PLANNING COMMISSION STAFF REPORT

MEETING DATE: January 24, 2022

AGENDA ITEM TITLE: 1. Residences at Salida Bottling Company Planned Development; and
2. Residences at Salida Bottling Company Major Subdivision

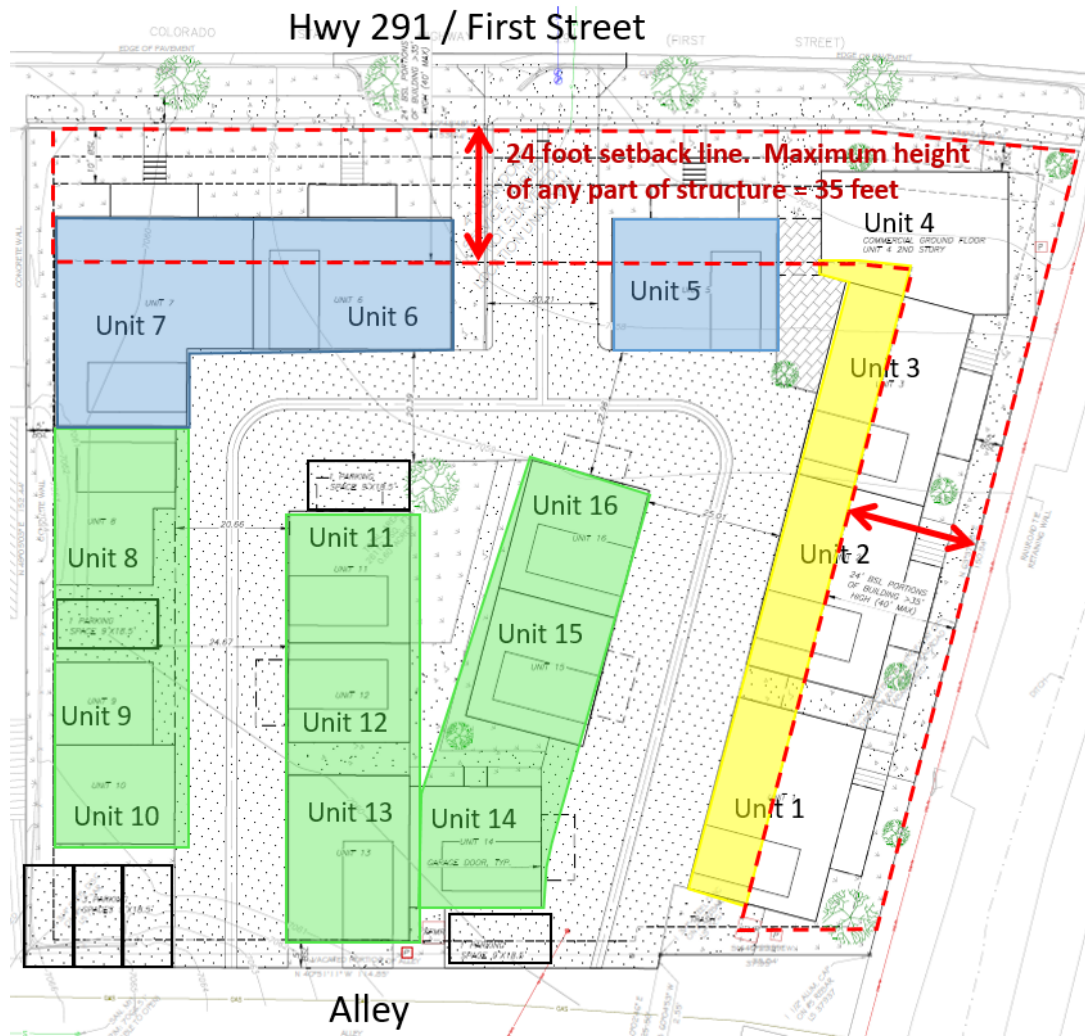
8. Maximum Height: The applicant is requesting a deviation from the maximum building height of 35 feet in C-1 to allow some of the structures to be a maximum of 40 feet. The applicant is also requesting a deviation to the maximum number of stories allowed in the Hwy 291 Existing Residential Overlay District, which is limited to 2 stories. However the limitation to 2 stories does not explicitly restrict the allowed building height to anything less than 35 feet. The request is to allow 3 stories for the green and blue buildings, plus rooftop access structures in certain locations.

The Overlay District states: “New infill development shall be similar to the size and scale of buildings adjacent to the development. The design of buildings shall look appropriate to and compatible with their surroundings and shall not exceed 2 stories.” The size of the building footprints is compatible with surrounding buildings. The design of the buildings, as previously noted, is intended to be complementary to Salida’s nearby historic buildings, including buildings formerly on this site.

The applicant has proposed a minimum 24 foot setback along Hwy 291 and the Monarch Spur Trail for any part of a building that exceeds 35 feet in height. This is shown by the **red dashed line** below. Staff recommends the following condition of approval:

- On Units 1-7, no portion of the building nor architectural appurtenances can exceed 35 feet in height within 24 feet of the property line along Hwy 291 or the Monarch Spur Trail.

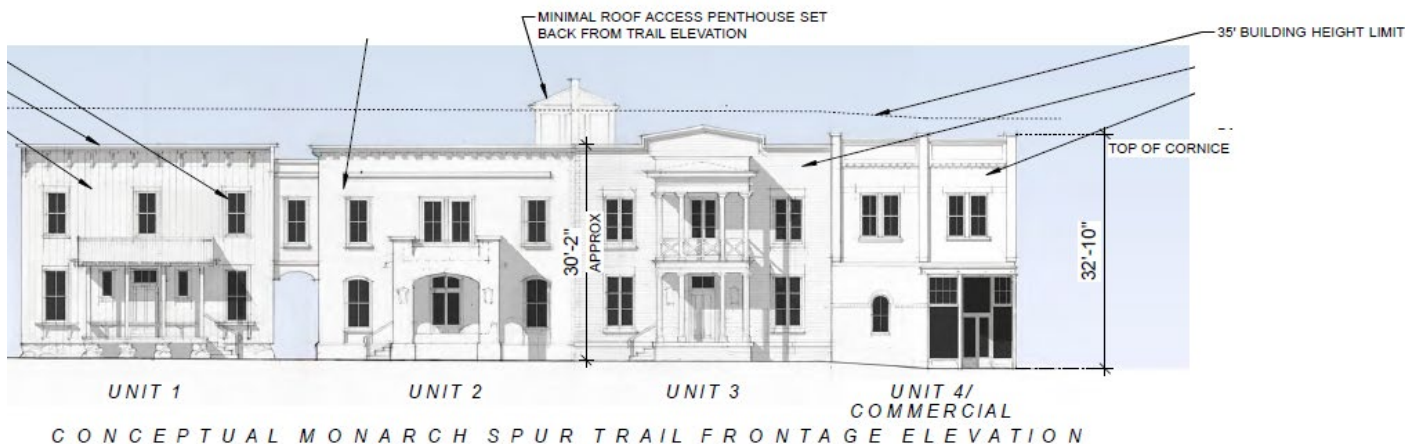
Units 1-4 (illustrated below and in yellow on the site plan). Units 1-4 are proposed at the allowed 2 stories for the majority of the structures. A deviation is requested for the portions of Units 1-4 shown in yellow on page 8, in which the applicant is requesting the ability to locate a rooftop access

structure, limited to 100 sf per unit, with a maximum height of 40 feet to the highest point of the structure.

Staff recommends that the request be limited to the minimum necessary to allow rooftop access and only where it will not potentially obstruct prominent view corridors from downtown. Therefore staff recommends that rooftop access on Units 2 & 3 be allowed only as one combined structure at a total of 100 sf for the two units, and recommends that no rooftop access structure be allowed on Unit 4 due to the higher visibility of that location from downtown and the potential obstruction of prominent viewsheds. Unit 1 would be limited to a single, 100 sf maximum, rooftop access structure. The recommended condition of approval is:

- Units 1-3 are allowed a rooftop access structure that cannot exceed 40 feet in height at its highest point. It may be up to 100 square feet on Unit 1. Units 2 & 3 are allowed a shared rooftop access structure up to 150 square feet (in total, not per unit). Shared structure can be greater than 150 square feet only if required by the Building Official, and shall be limited to the minimum required square footage. No rooftop access structure is allowed on Unit 4.

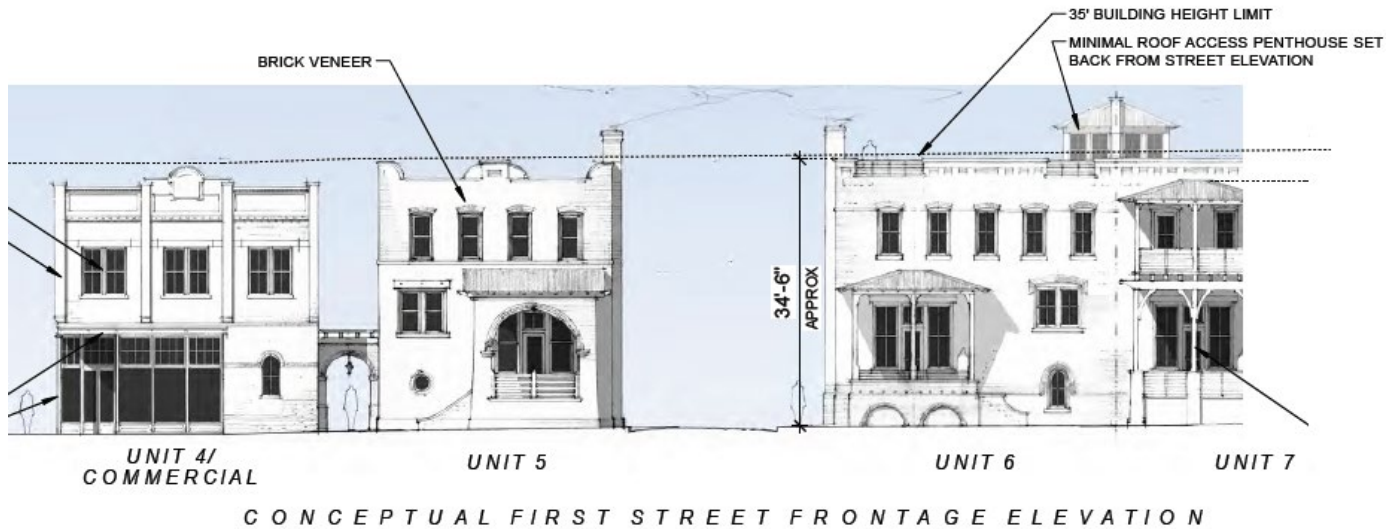
➤ **Units 5-7** (illustrated below and in blue on the site plan). The applicant is requesting a deviation to allow Units 5-7 to be 3 story buildings. The proposed maximum height of the 3 stories is 35 feet, which does not require a deviation. However, a deviation is requested to allow a rooftop access structure, limited to 100 sf per unit, to be a maximum of 40 feet at its highest point. Additionally, the applicant has requested an allowance for chimneys up to 40 feet.

The request for 3 stories along 1st Street will allow for the accommodation of the proposed historically relevant architectural design that is unique for new construction. It is a design that, when viewing from 1st & F Street, reads as an extension of the historic downtown. The primary structure will be a maximum of 35 feet in height, which is allowed in the Overlay District. Therefore staff supports the request for 3 stories. Staff recommends that the rooftop access request be limited to the minimum necessary and only where it will not potentially obstruct prominent view corridors from downtown. For this reason, staff recommends that no rooftop access structure be allowed on Unit 5 and that rooftop access on Units 6 & 7 be allowed only as one combined structure at a total of 100 sf. The recommended condition of approval is:

- Units 5-7 can be a maximum of 3 stories and 35 feet in height with the exception of chimneys and a rooftop access structure on Units 6 & 7. Units 6 & 7 are allowed a shared rooftop access structure that cannot exceed 40 feet in height at its highest point, and can be up to 150 square feet (in total, not per unit). Shared structure can be greater than 150

square feet only if required by the Building Official, and shall be limited to the minimum required square footage No rooftop access structure is allowed on Unit 5. Chimneys shall not exceed 40 feet.

Example of rooftop decks on the gabled roof portion of the site, potentially Units 8-16.

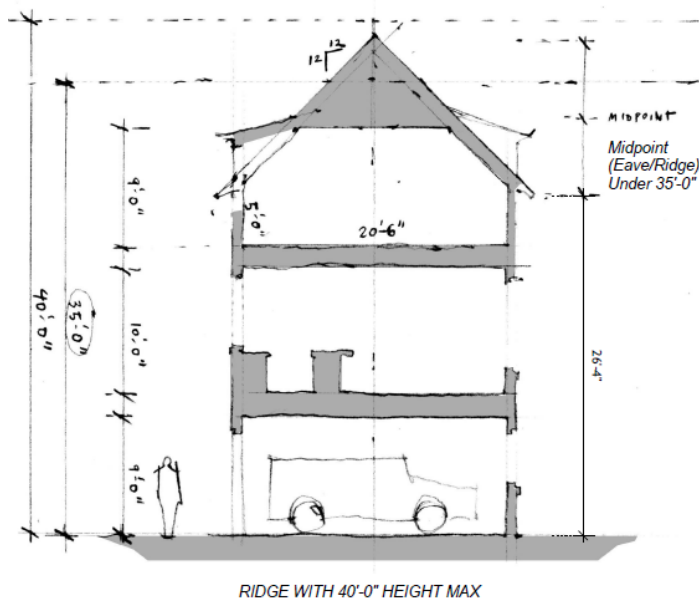
Units 8 -16 (building section below, and shown in green on page 8). The applicant has requested a deviation to Units 8-16 to be 3 stories, and a deviation to allow 40 feet in height. As shown in the illustration below, the allowance for 40 feet would be to accommodate the peak of the gabled roof. These units do not front Hwy 291, are separated from the property to the south by an alley, and are adjacent to a gas station to the west. Staff supports the request for 3 stories off of Hwy 291. If the building height deviation to 40 feet is approved, staff recommends conditioning it to only accommodate a gabled roof and not a flat roof.

The conceptual rendering below shows potential rooftop decks on this portion of the site. Specific details were not provided for these decks. Staff recommends that no portion of the deck (including railings, shade structures, etc) shall exceed 35 feet in height. This condition will ensure that a person standing on the deck will not be visible above a 40-foot peaked roof.

- Units 8-16 can be a maximum of 3 stories. They can be a maximum of 40 feet in height only to accommodate the peak of a gabled roof. No part of a rooftop deck, including railings or covers, can exceed 35 feet.
